**METROPOLITAN GOVERNMENT OF NASHVILLE AND DAVIDSON COUNTY**

**STAFF RECOMMENDATION**  
**1311 Lillian Street (Rear of 1308 Fatherland Street Lot)**  
**December 18, 2019**

**Application:** New Construction—Infill  
**District:** Lockeland Springs-East End Neighborhood Conservation Zoning Overlay  
**Council District:** 06  
**Base Zoning:** R6  
**Map and Parcel Number:** 083132D00200CO  
**Applicant:** Craig Huseby, Builder  
**Project Lead:** Sean Alexander, sean.alexander@nashville.gov

<p><b>Description of Project:</b> A proposal to construct a new house on a lot with two street frontages, on which there is currently a house facing Fatherland Street. The new house will face Lillian Street and will be one and one-half-stories tall.</p> <p><b>Recommendation Summary:</b> Staff recommends approval of the proposed one and one-half-story infill at 1311 Lillian Street with conditions that:</p> <ol style="list-style-type: none"><li>1. The finished floor height shall be consistent with the finished floor heights of the adjacent historic houses, to be verified by MHZC staff in the field;</li><li>2. The front setback shall be consistent with the setbacks of the adjacent historic houses

**SITE PLAN - ARCHITECTURAL**

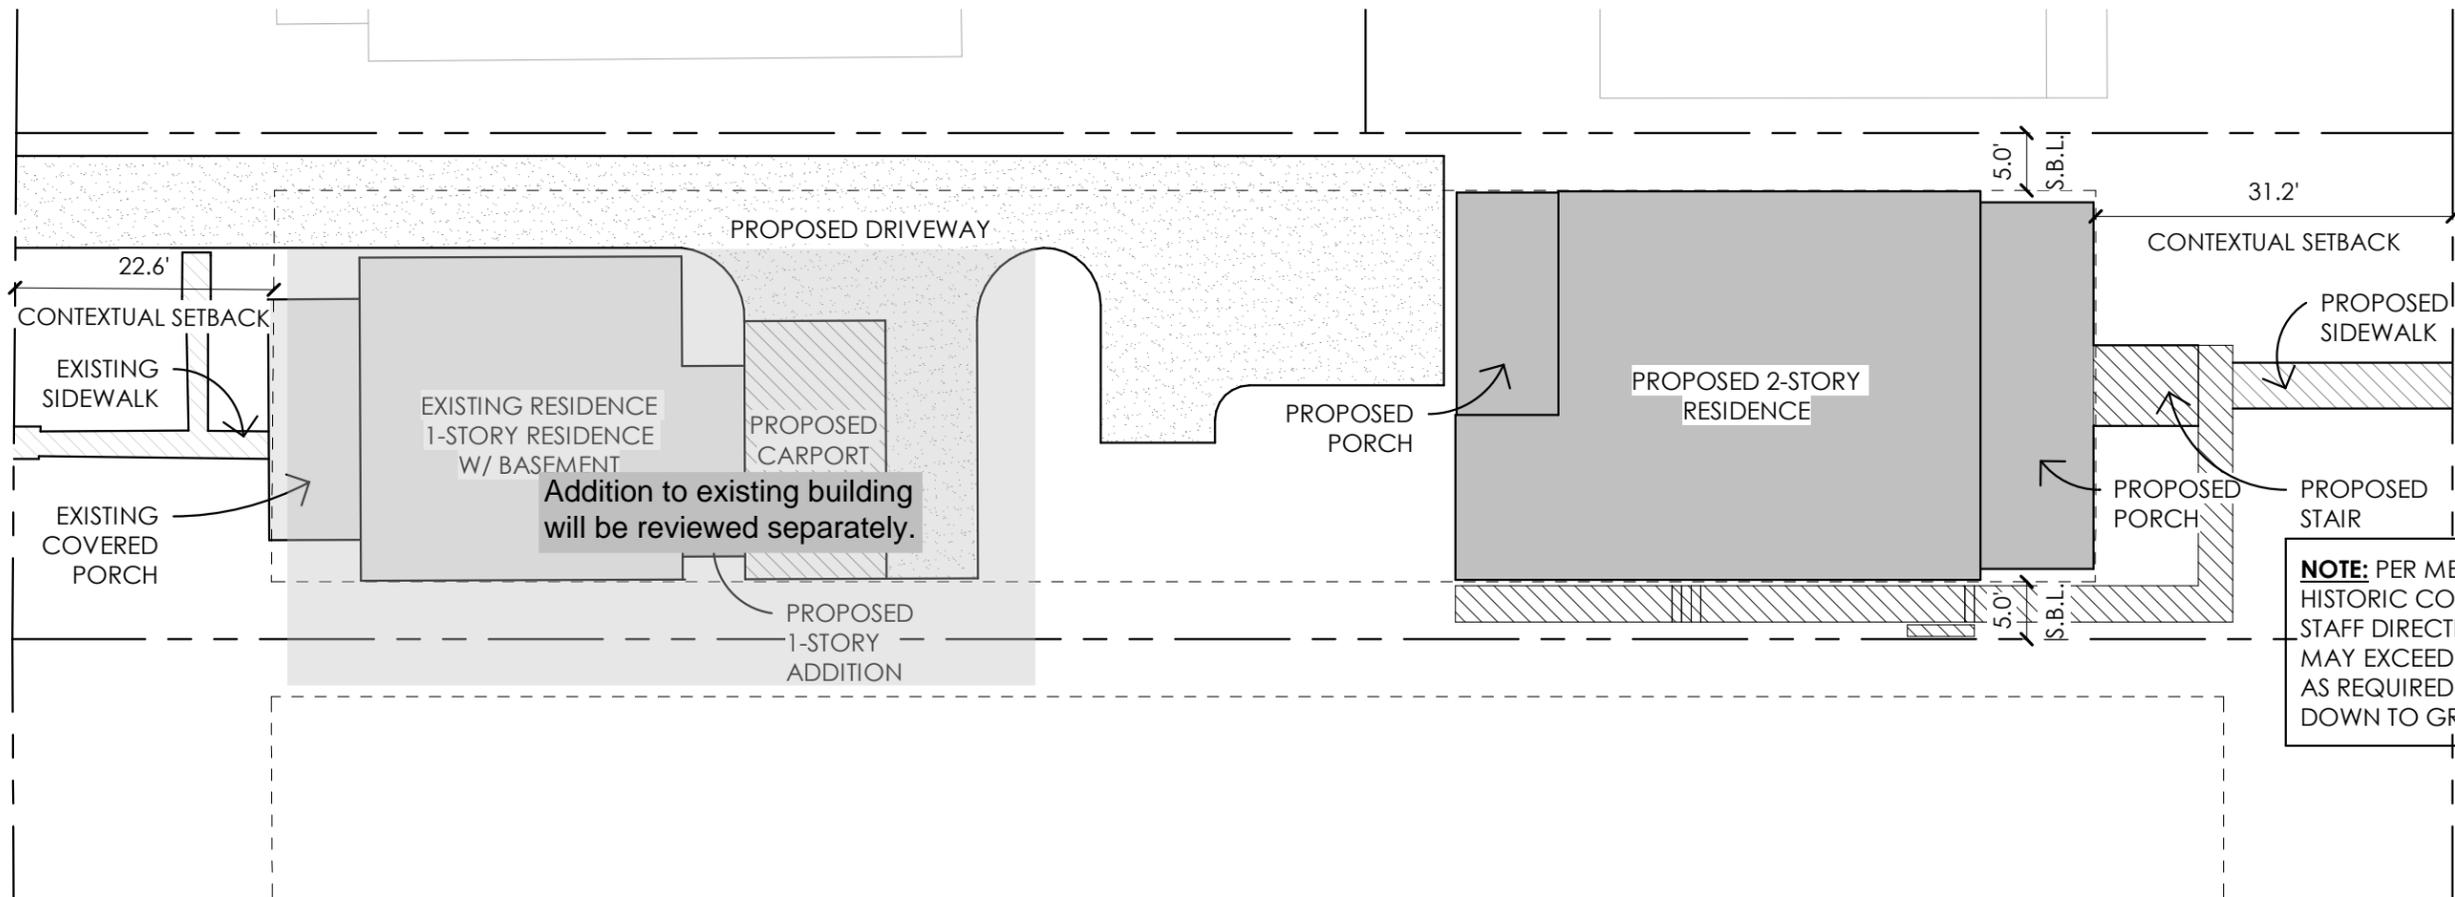
Setback & Rhythm of Spacing: The front edge of the building is proposed to be twenty-three feet (23') from the front of the lot, which is in line with the houses on either side. The building's side setbacks will be five feet (5') on the right side and ten feet (10') on the left. This meets bulk zoning requirements and is consistent with the rhythm established by existing houses on the street, most of which are shifted to one side of the lot. Staff finds that the project will meet Section II.B.1.3. of the design guidelines.

With a condition that Staff shall verify the front setback at the start of construction, Staff finds that the front and side setbacks will meet section II.B.3 of the design guidelines.

Appurtenances & Utilities: An existing driveway from Fatherland Street will be extended to the rear of the new house facing Lillian Street, with an easement created to allow use by both houses. This does not disrupt the established patterns of the 1300 blocks of Fatherland or Lillian Streets because there is no alley between the two streets, therefore driveways and street parking are common. The location of the HVAC and other utilities were not noted.

1. The finished floor height shall be consistent with the finished floor heights of the adjacent historic houses, to be verified by MHZC staff in the field; and
2. The front setback shall be consistent with the setbacks of the adjacent historic houses, to be verified by MHZC staff in the field; and
3. Additional screening shall be added on the front of the building; and
4. The window and door selections shall be approved by MHZC Staff; and
5. The roof color shall be approved by MHZC Staff; and
6. The utility connections and HVAC units shall be located behind the midpoint of the building on a non-street facing façade.

EXTERIOR ELEVATIONS

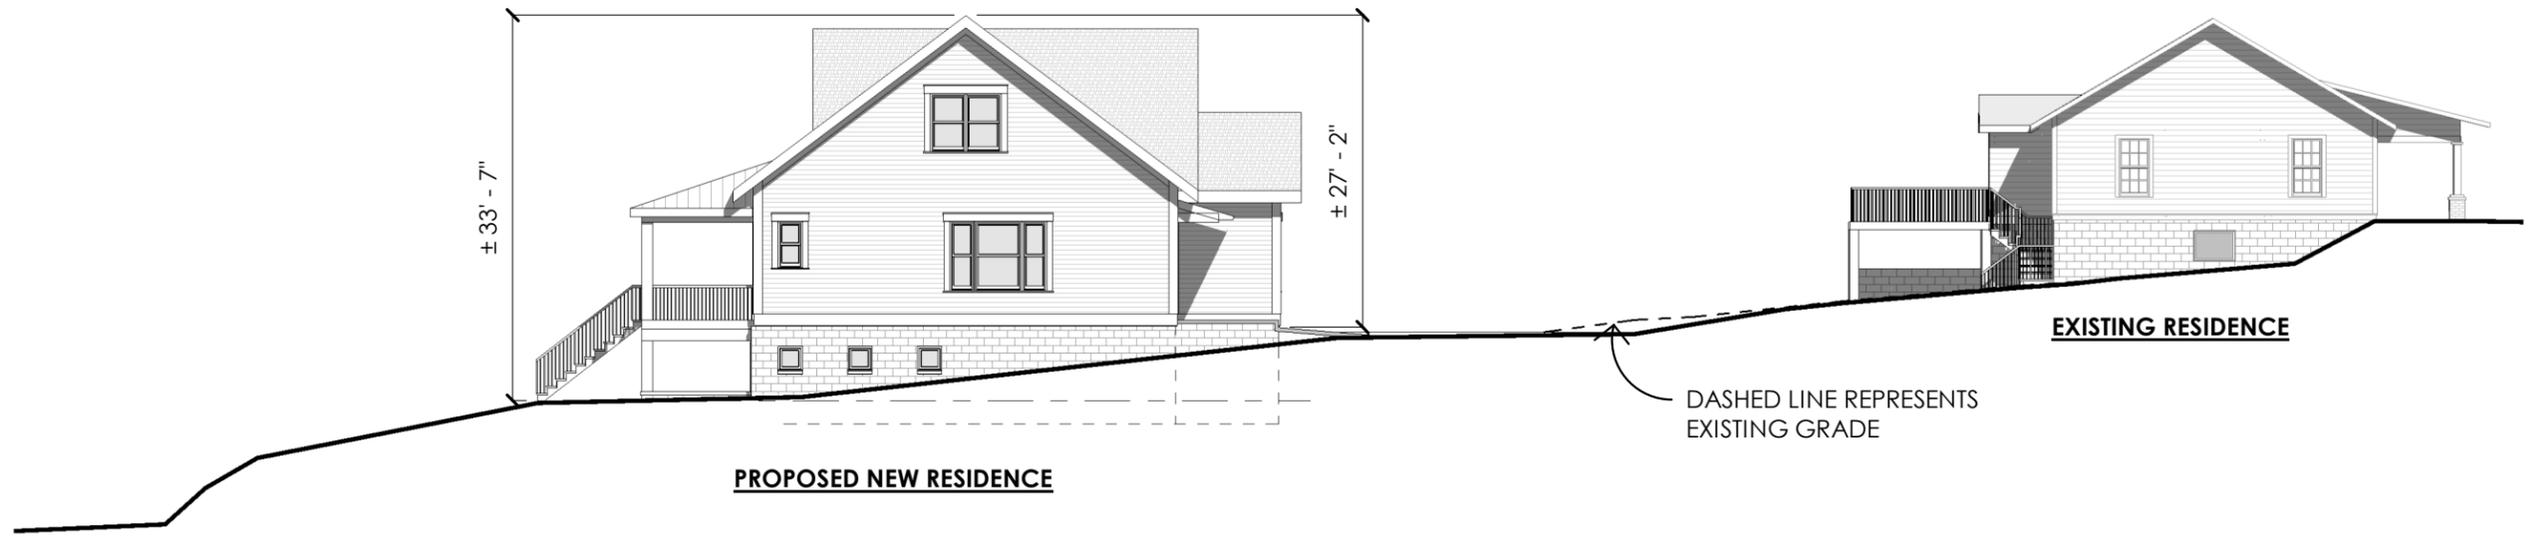
**Height & Scale:** The new building will be a one and one-half-story house, which is compatible with the houses on the block and the surrounding area. The house will be twenty-six feet (26’) tall from the floor level to the peak of the roof. Due to the significant drop in grade from the rear to the front, the foundation at the front of the building will be as tall as seven feet (7’) at the highest point. While this is taller than would be appropriate in most locations, the height of the floor level above the grade at the rear of the structure is typical at approximately two feet (2’). Staff finds the foundation height is appropriate as a result of the grade of the lot. With an approximately ten inch (10”) wide water-table band below the floor level, the overall height of the house at the front will be approximately thirty-three feet (33’) from grade. The primary eave height on the building will be ten feet (10’) tall, measured from floor level. This matches the height and massing of three recently constructed houses on this block face: 1113, 1115, and 1208 B Lillian Street.

**Roof form:** The primary roof of the building will be a side-gable with a front-gabled dormer. The pitch of the primary roofs will be 12/12. The front porch will have a projecting hipped roof form with a 4/12 pitch.

**Proportion and Rhythm of Openings:** The window openings on the new building will comprise mostly double-hung and fixed sashes vertically oriented and arranged in single units, pairs, and sets of threes. There will be a square window on the left wall beyond the midpoint, and square windows in the sides of the foundation wall. The sizes and spaces between openings on the primary facades will be consistent with the openings on nearby historic houses.
